HISTORIC PRESERVATION COMMISSION

SUBJECT: Historic Area Work Permit #1094686 – Porch alterations and fenestration alterations, basement

The Montgomery County Historic Preservation Commission (HPC) has reviewed the attached application for a Historic Area Work Permit (HAWP). This application was **Approved with three (3) conditions** at the December 18, 2024 HPC meeting:

RENOVATION OF THE CLAYTON / WATKISS RESIDENCE

PROPOSED ELEVATION
SCALE: 1/4" = 1'-0"

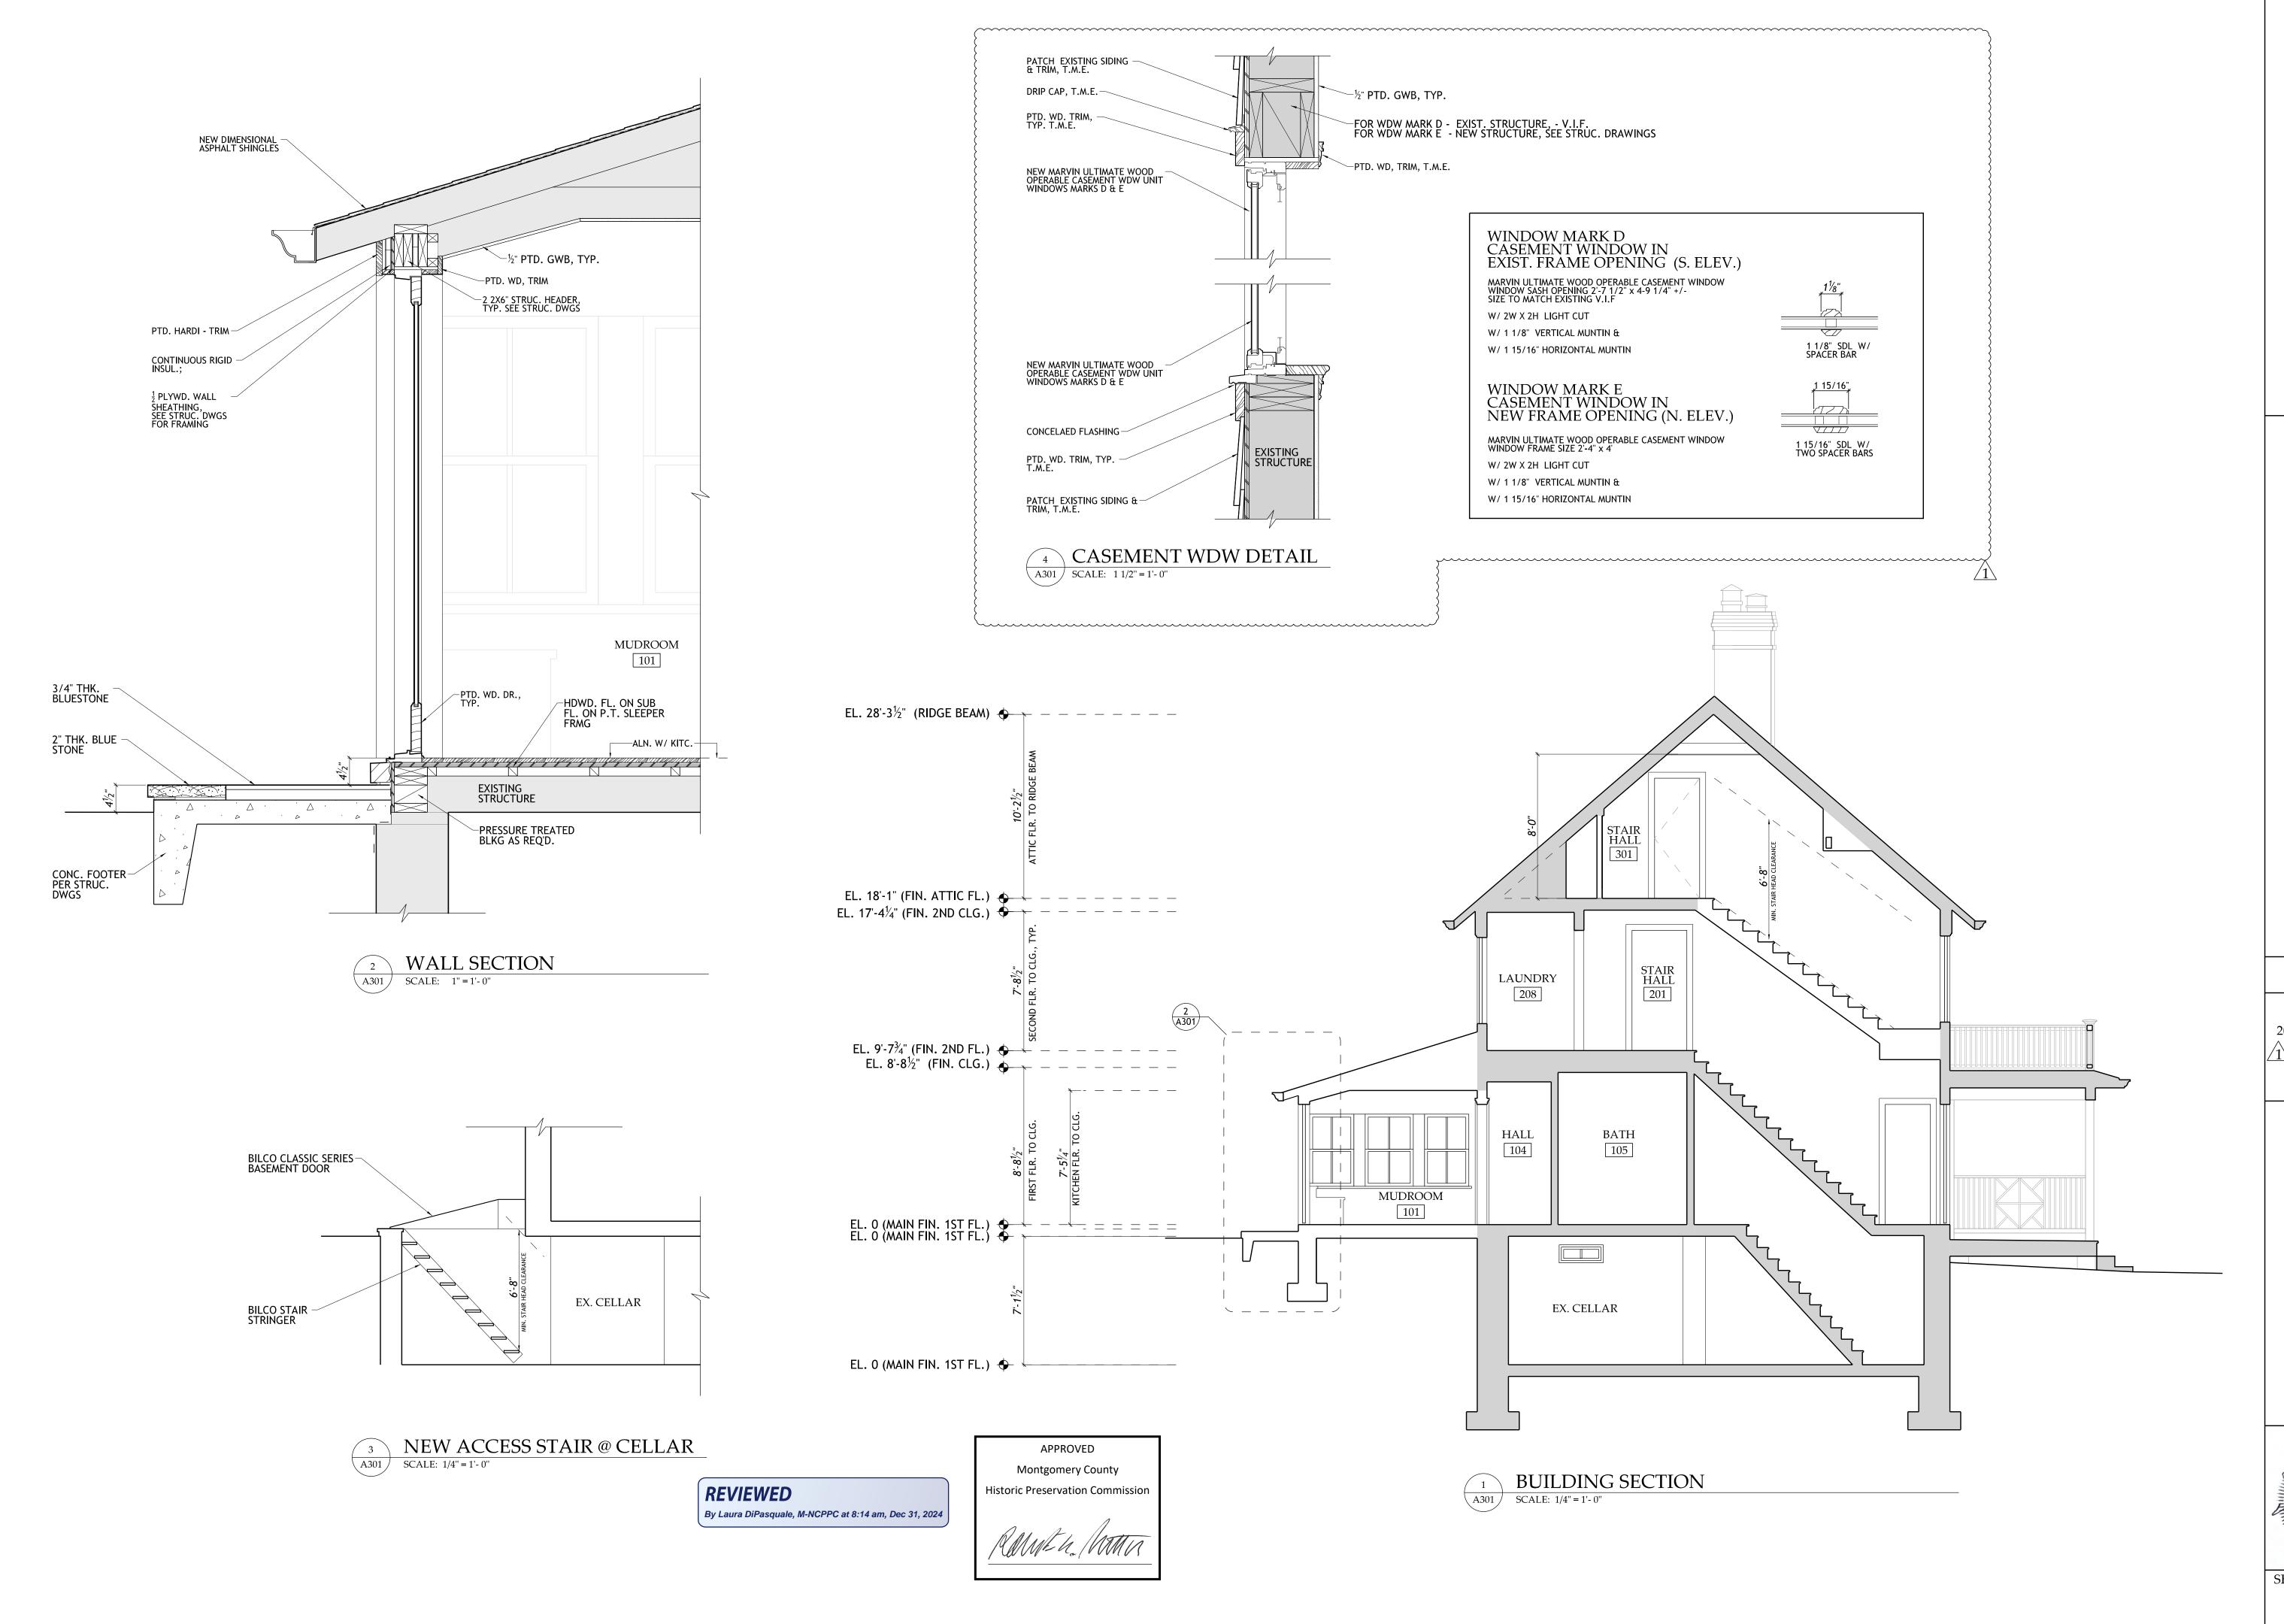
- 1. The north attic window must be reduced in size to avoid impacting the bargeboard, and the shutters eliminated.
- 2. The new steps proposed on the south side of the front porch must be constructed of wood.
- 3. The applicant must submit dimensioned window specifications and/or window installation details for the proposed new and replacement windows. The proposed replacement window on the south elevation must match the dimensions of the existing window.
